Re: Midwestern Farms, Permit No. M-1993-059, Technical Revision No. 5, Adequacy Review No. 1 – Eastern Colorado Aggregates Response.

Midwestern Pit - Permit M1993-059 - TR005, REV NO. 1

RECLAMATION PLAN MAP

Permit Name - Midwestern Farms
Reclamation Permit No. M1993-059

EXHIBIT E-1 (REVISED 6:1 CROSS SECTION)

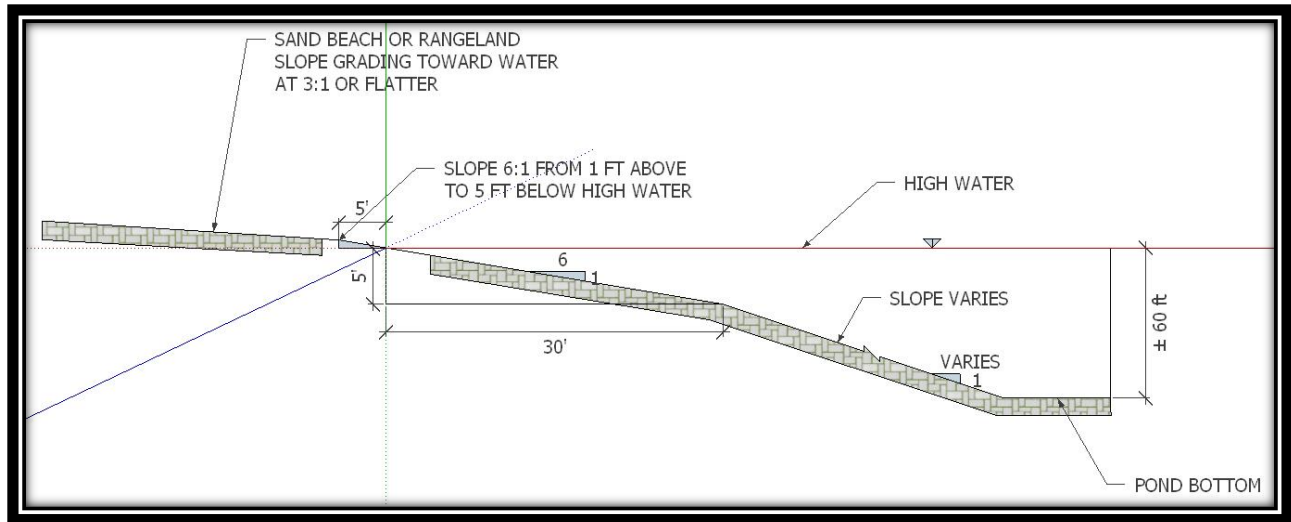
2. **Pond Slopes** - Pond slopes will be reclaimed per the attached Exhibit E-1, E-2, E-3 and Exhibit F – Reclamation Plan Map.
 - a. How does the operator intend to achieve these slope gradients below the water line? - The ponds will be partially drained and slopes will be excavated to the approved sections.

25. Refer to Exhibit E – Reclamation Plan revised cross sections E-1, E-2 and Exhibit F Reclamation Plan Map. The CPW has requested specific sections of pond shoreline to be left in their current condition. CPW has also requested that sections of shoreline be graded at 6:1 and 3:1 cross sections at various locations which are indicated on the CPW map. All other shorelines are requested by CPW to remain at their current slope.

- d. Please see our revised Exhibits E-1, E-2 cross sections, Exhibit E-3 map and Exhibit F – Reclamation Plan Map which show the reclaimed shore line details as requested by CPW.

Exhibit F

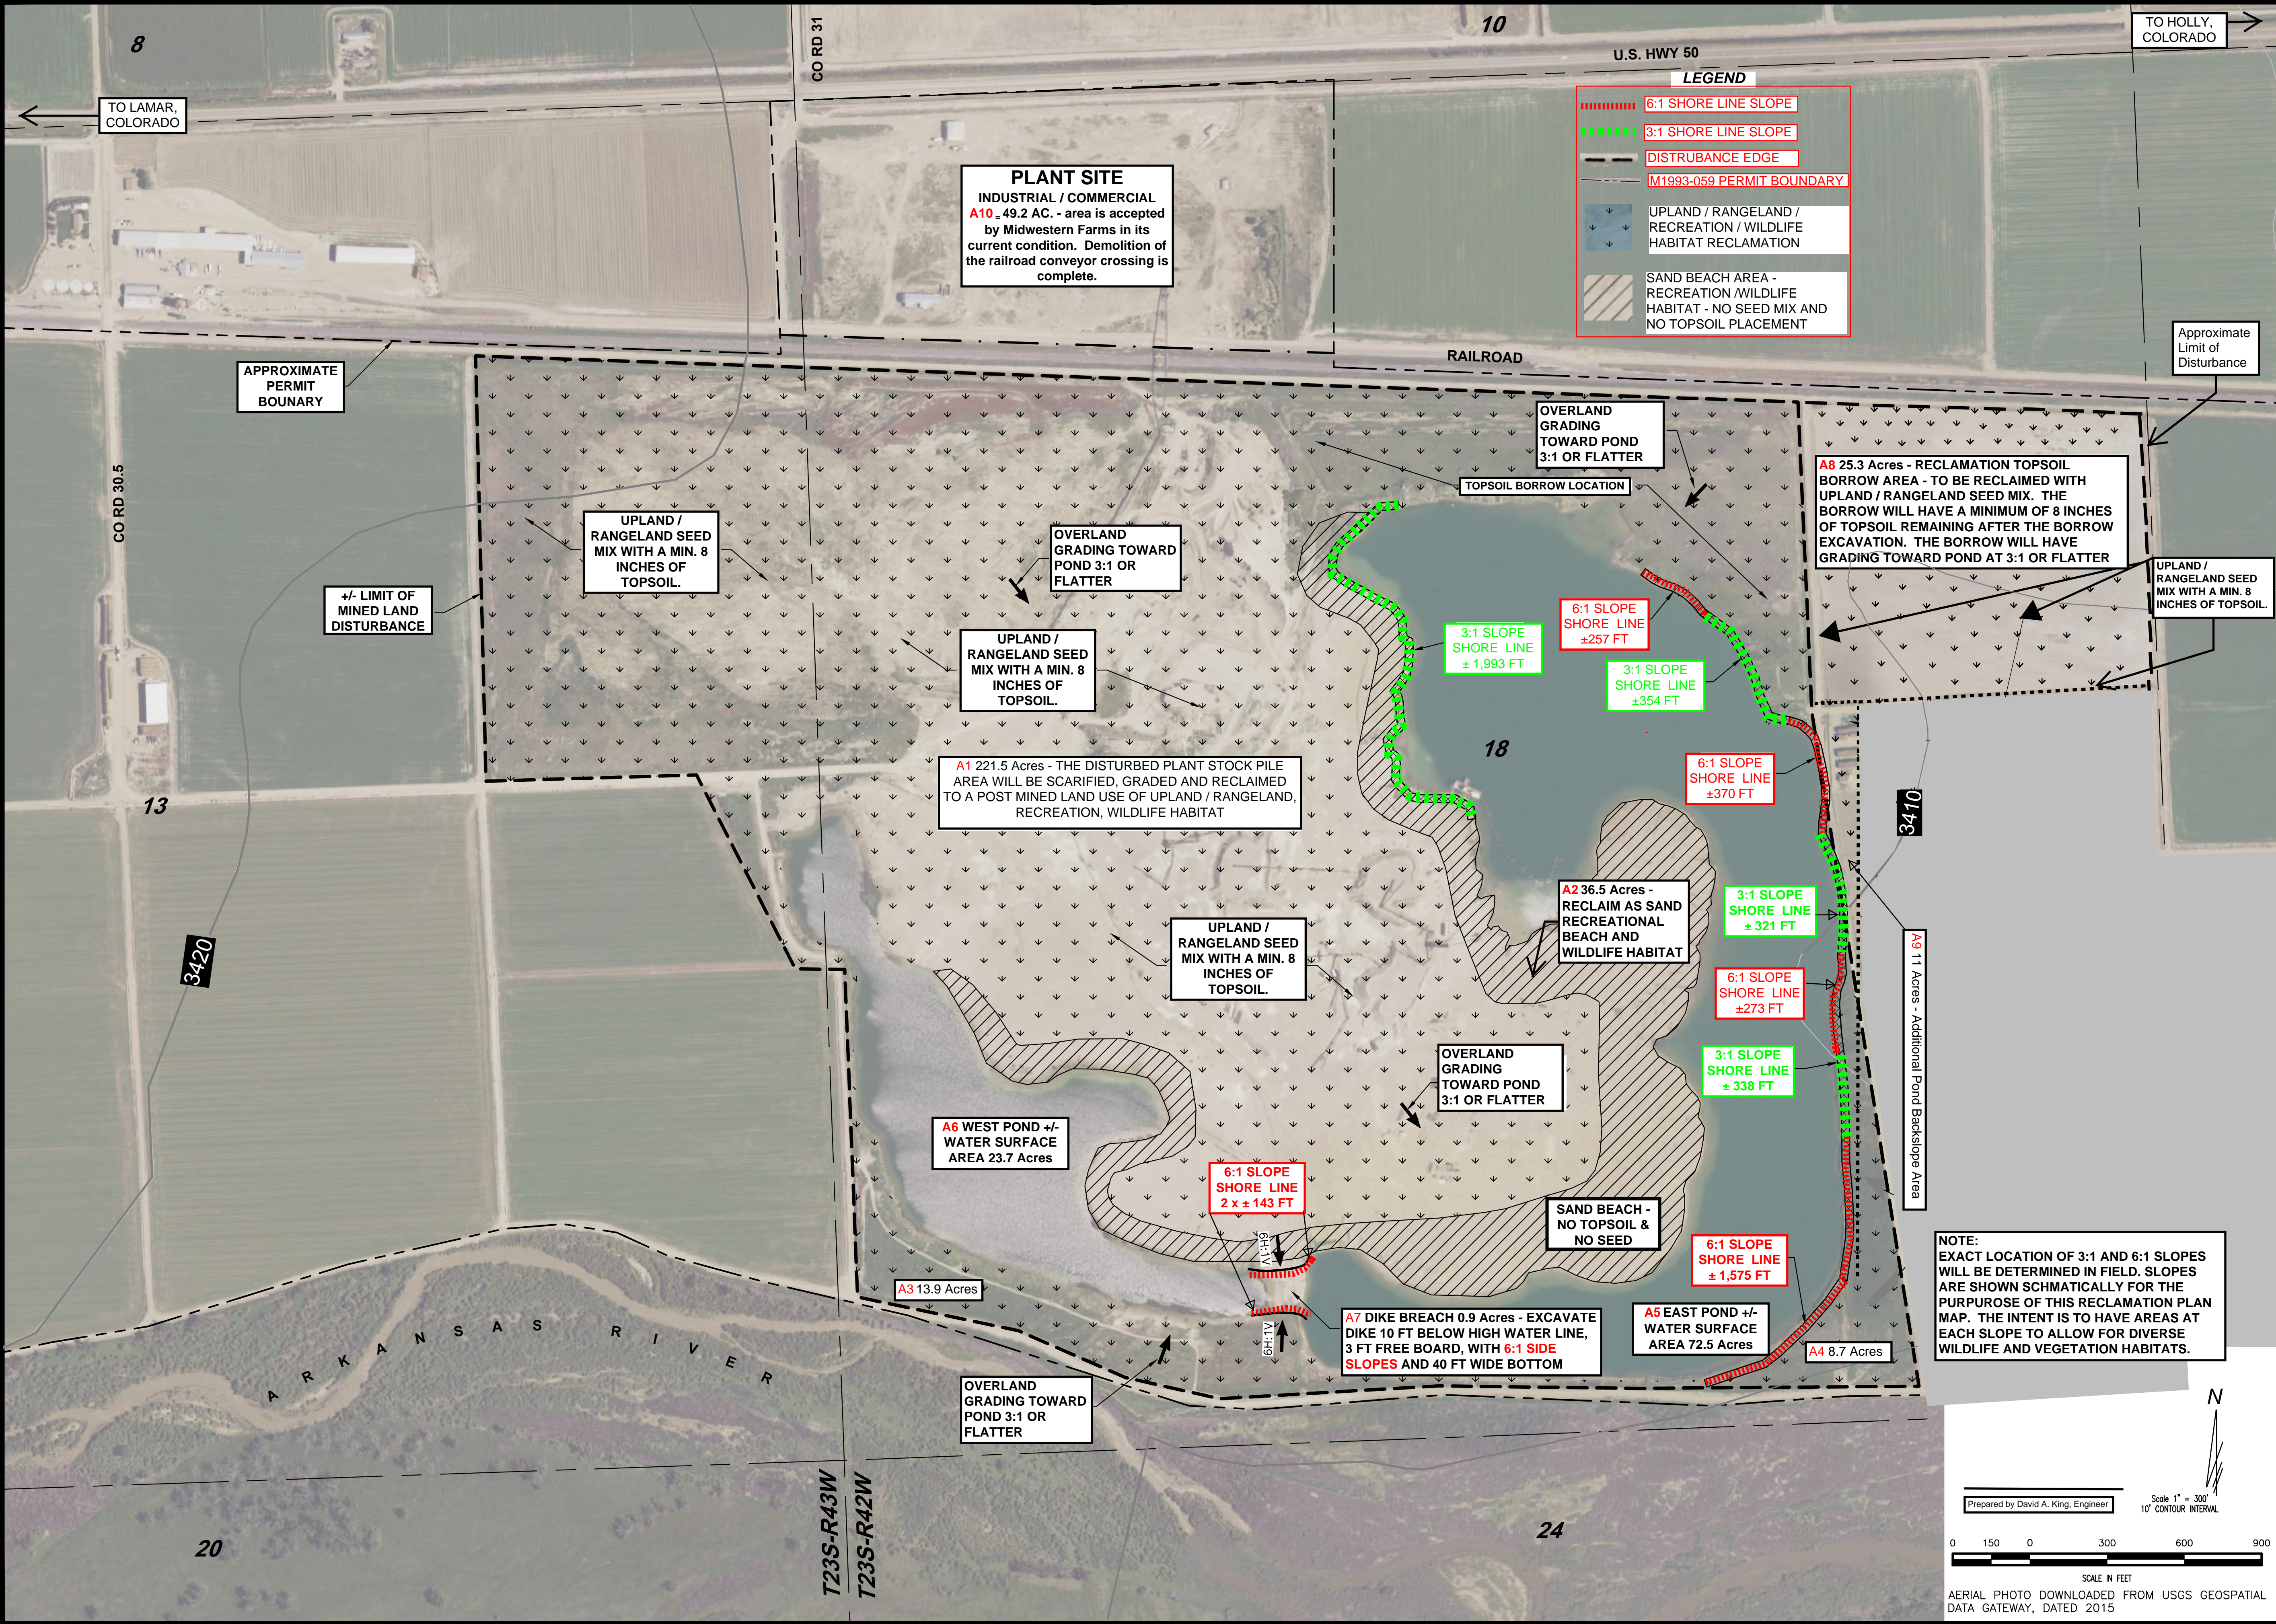
7. **Exhibit F – Reclamation Plan Map** - Please see the revised and legible copy of the Exhibit F – Reclamation Plan Map.
8. **Technical Revision Cover** - Please see the revised Technical Revision Cover Sheet to include upland, range land and recreation in the description.

16. Please see the revised and legible Exhibit F – Reclamation Plan Map.

Item Number 14), addresses the issue of not re-vegetating certain areas of shoreline, particularly along the north-central shoreline area as denoted in "Exhibit F". A vegetation free shoreline is beneficial to many species of shorebirds for nesting, feeding and loafing areas, and waterfowl tend to prefer these clear areas for roosting/resting. Additionally, waterfowl species find the sandy/gravelly shorelines attractive for providing grit needed in their digestive process. Two threatened and endangered shoreline bird species, the Piping Plover (*Charadrius melodus*) and

Least Tern (*Sterna antillarum*), are known to nest in areas along the Arkansas River. A Least Tern nest has been observed on the mining site in the past, and CPW believes it important to continue managing for these species at the site. Both species nest in sandy gravel substrate free of vegetation. CPW staff therefore request leaving certain areas as designated on "Exhibit F" free of vegetation. This would be most beneficial to wildlife use of the site.

- a. Please see revise Exhibit F – Reclamation plan map which shows the additional topsoil borrow area.
 - b. The approximate depth of top soil striping and replacement will be 8 inches.

- a. The current disturbed area with the industrial/commercial area = 426.9 acre, which is less than the 439.2 acres. The additional land is for the NEx topsoil borrow area and the east side pond back slope area. Please refer to Exhibit F – Reclamation Plan Map and the following table.

6:1 shore line grading = $(2,475 \text{ ft})(35 \text{ ft})(0.5 \text{ ft}) = 43,312 \text{ cf} / 27 \text{ cf/cy} = 1,604 \text{ cy}$
24. Please disregard this statement “Disturbed outer edges 50 acres”. Please refer to revised Exhibit F – Reclamation Plan Map and Revised Exhibit L – Reclamation Cost for clarification of the existing disturbed areas, top soil borrow area and the eastern shore back slope area.
